LOGISTICS SHOP RENOVATION

INVITATION TO BID - REQUISITION NO. 2021-0128

ADDENDUM NO. ONE (1) - DATED JANUARY 15, 2021

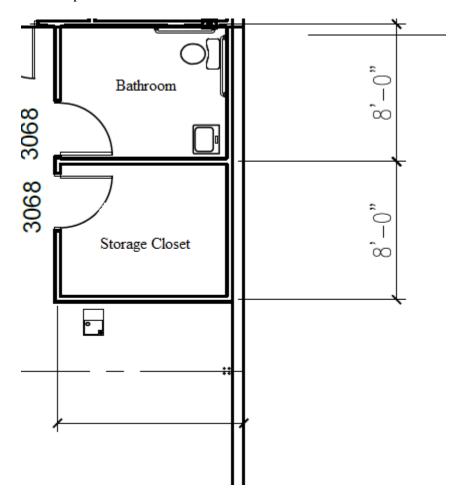
3. Addition of Interior Bathroom and Storage Closet Rebuild Additive Alternate

An additive alternate has been included with a scope of work to rebuild the interior bathroom and storage closet, and to add a drinking/water fountain. Please reference the following sketch.

Measurements are approximate. The footprint of this structure shall be the same or close to the current structure. The location of the water fountain is flexible. The rebuild shall include new sheetrock walls, hard ceiling, and LVT flooring. Plumbing shall be rerouted away from the ceiling to improve the integrity of the roof. Plumbing shall be capped in the storage closet. The rebuilt bathroom shall have a new toilet and wall-hung vanity without a shower. The entire structure shall be ADA compliant.
